DEVELOPMENT ASSESSMENT REPORT	
Application No.	DA/2020/0635
Address	28 Merton Street ROZELLE NSW 2039
Proposal	Demolition of the existing dwelling house and construction of a new dwelling house, new double garage with studio above and terrace area under at rear, and associated works, including swimming pool and tree removal.
Date of Lodgement	06 August 2020
Applicant	Dalgliesh Ward & Associates Pty Ltd
Owner	Leo Raso
Number of Submissions	12 Total
Value of works	\$913,750.00
Reason for determination at Planning Panel	Number of submissions Clause 4.6 variations exceed 10%
Main Issues	Variation to Site Coverage development standard Variation to Floor Space Ratio development standard Adverse impact on Laneway and bulk and scale (studio above garage structure) View loss implications.
Recommendation	Approval with Conditions
Attachment A	Recommended conditions of consent
Attachment B	Plans of proposed development

This report is an assessment of the application submitted to Council for the demolition of the existing dwelling-house and construction of a new dwelling-house, new double garage with studio above and terrace area under at rear, and associated works, including swimming pool and

The image below shows the proposed garage/studio structure with the above controls overlaid.

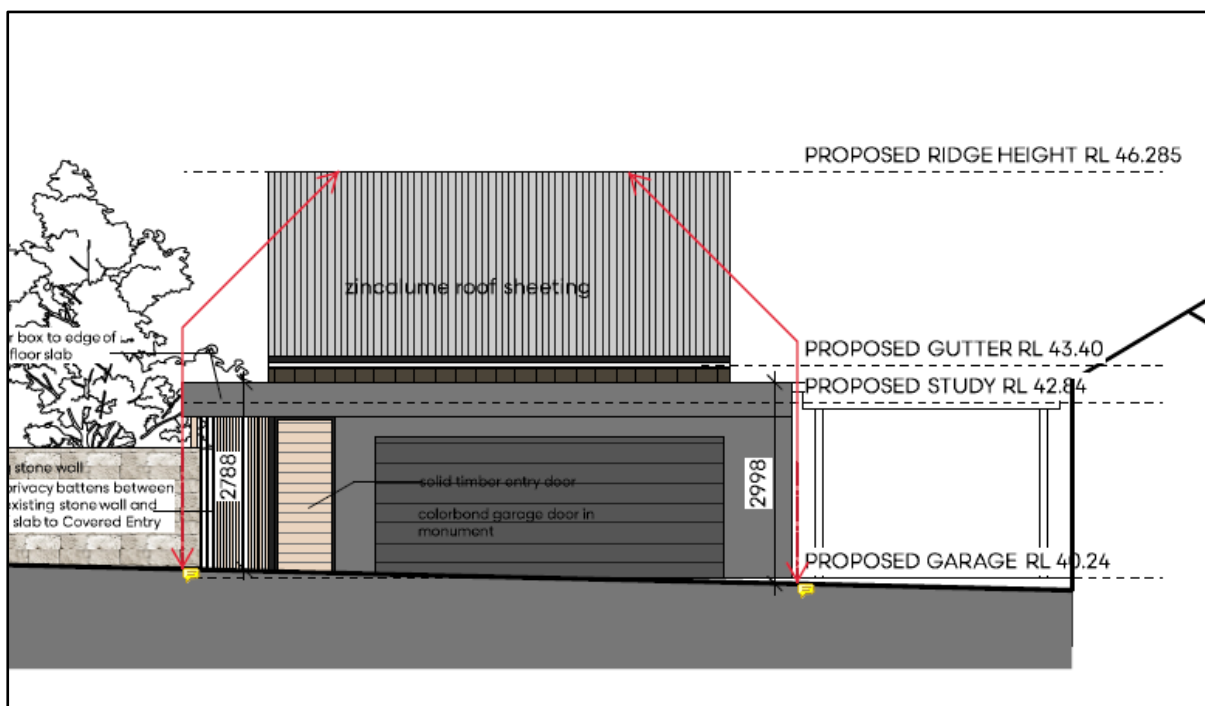
The proposed garage/studio structure does not comply with the above controls as the studio portion of the structure will penetrate the applicable envelope.

Planners Comment: For reasons discussed later in this report, the proposed studio above the garage is not supported and a condition requiring its deletion is recommended to the panel. The condition proposes to delete the studio and replace with a simple skillion roof.
